**Kaiser Aluminum**  
CORPORATE ENVIRONMENTAL

Re: May 7, 2001 Conference Call

Nuclear Regulatory Commission Teleconference  
Dated May 7, 2001  
Kaiser Aluminum & Chemical Corporation  
Tulsa, Oklahoma

On May 7, 2001, a teleconference to discuss the Kaiser Aluminum & Chemical Corporation's (Kaiser) letter response to the Nuclear Regulatory Commission's (NRC) Inspection Report 040-02377/00-02 was held. Attendees included yourself; Mr. M. David Tourdot of Earth Sciences Consultants, Inc.; Messrs. John Buckley, Louis Carson, and Jean-Claude Dehmel of the NRC; and myself. Specifically, Mr. Carson commented on all five deviations (01 – 05) and Messrs. Carson and Dehmel commented on one of six inspection follow up items (011). My summation of each is as follows:

**FIGURE 2**  
**AFFECTED AND UNAFFECTED AREAS**  
**ADJACENT LAND AREA REMEDIATION**  
**KAISER ALUMINUM**  
**TULSA, OKLAHOMA**  
 PREPARED FOR  
**KAISER ALUMINUM & CHEMICAL CORPORATION**  
**BATON ROUGE, LOUISIANA**

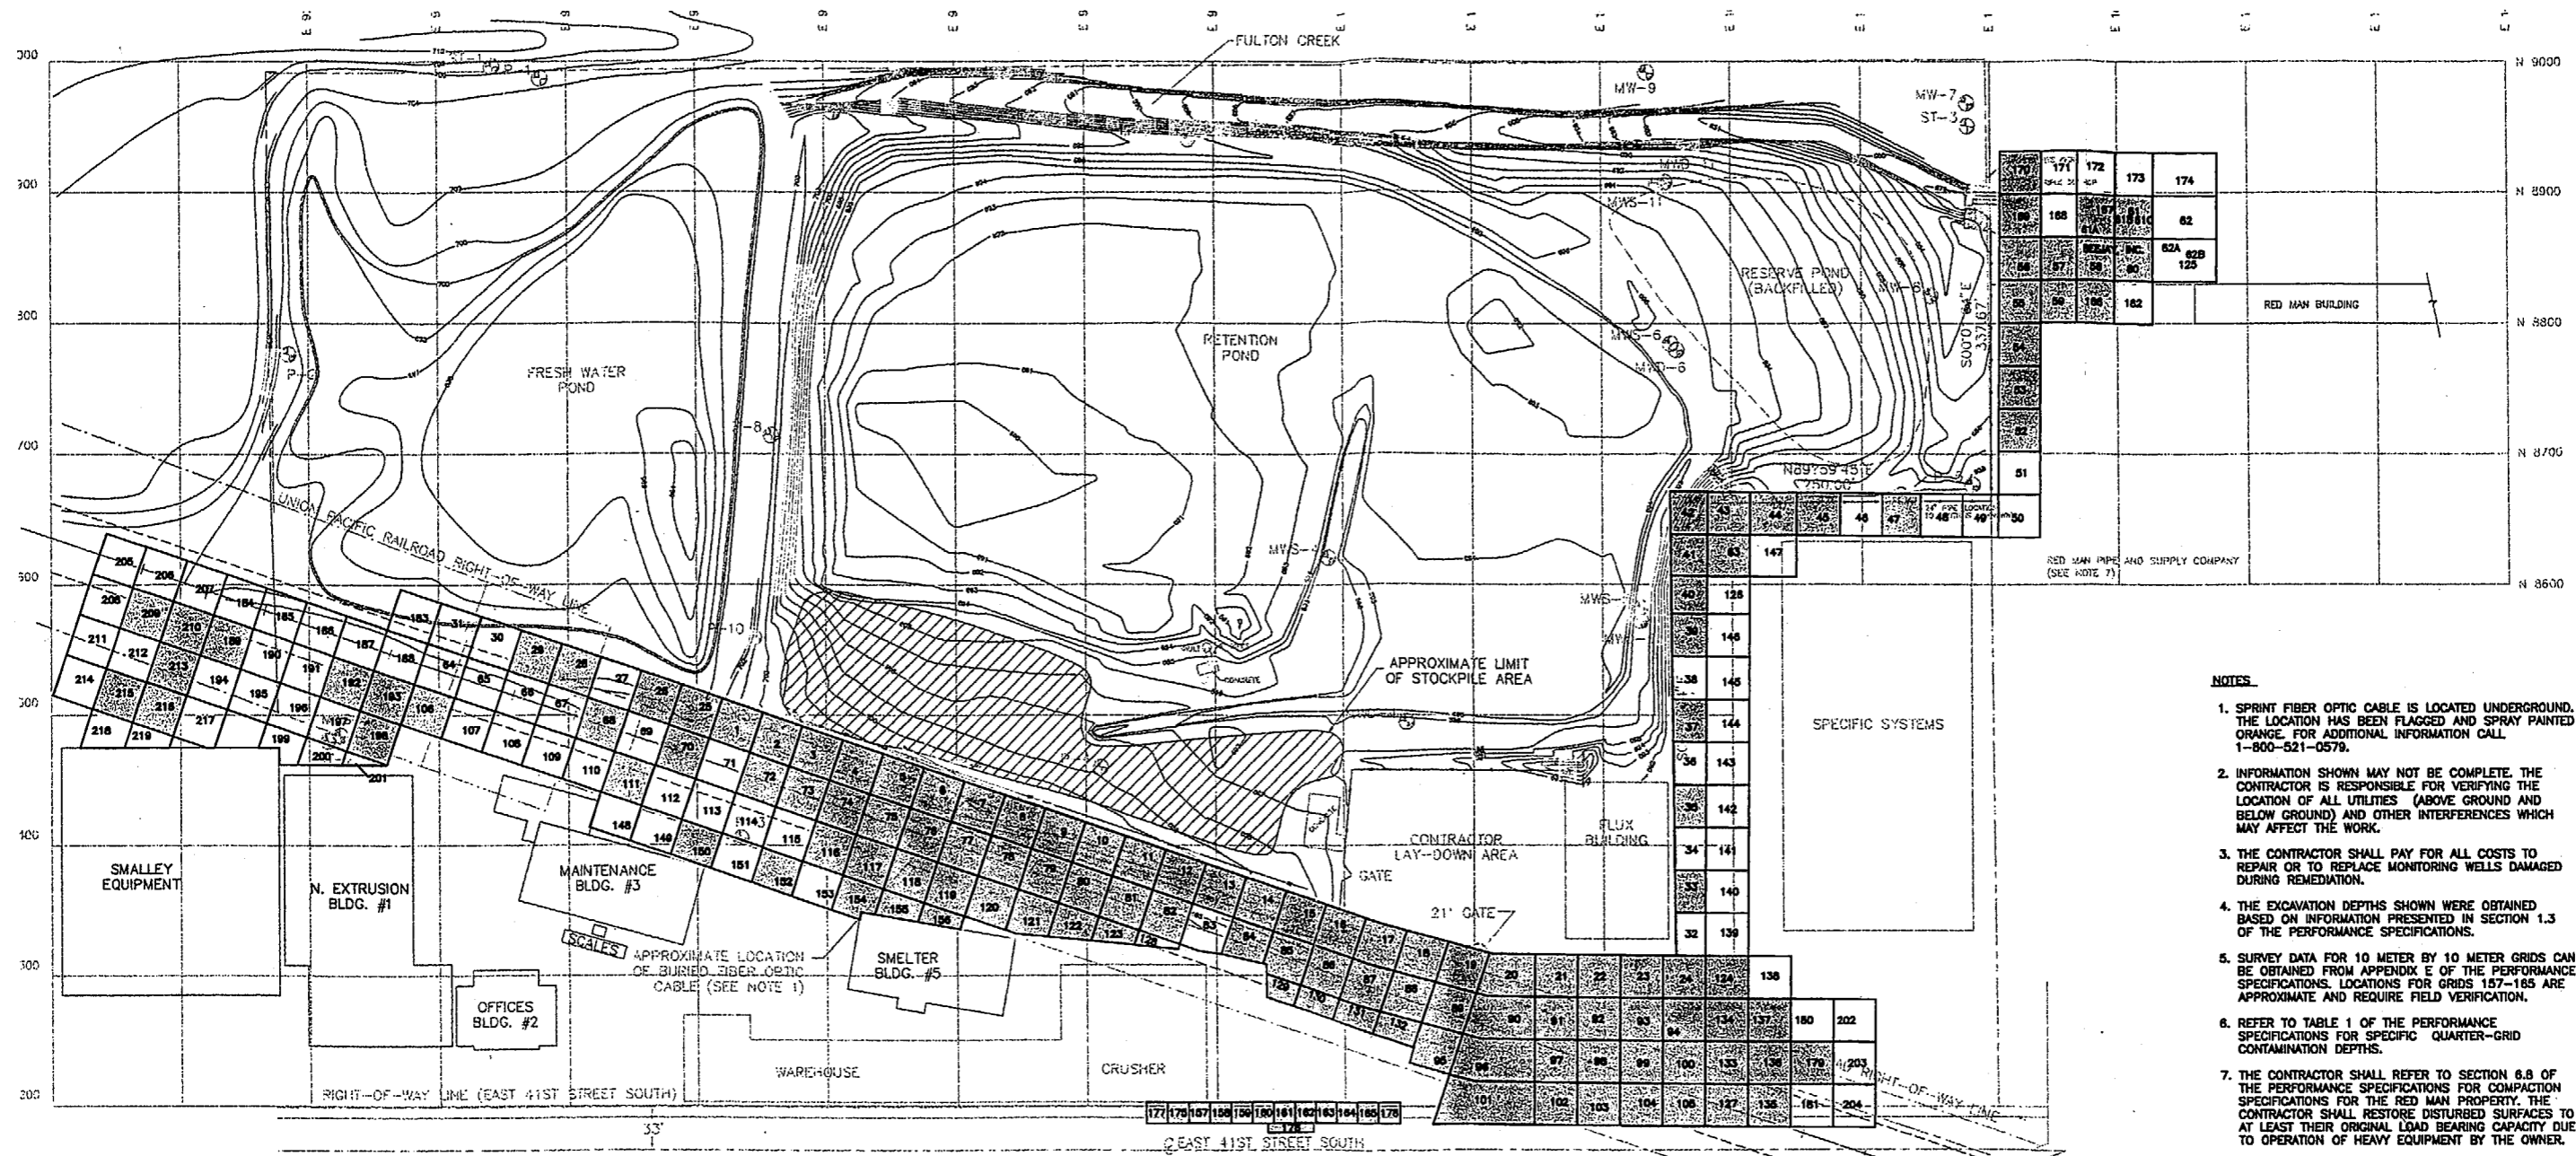
- DEV01 – An updated figure of the adjacent land area with all of the characterization grids delineated as affected or unaffected will be forwarded to the NRC. In addition, a matching table of Characterization Grids, their status (affected or unaffected), the basis of the status, and any additional comments are attached.
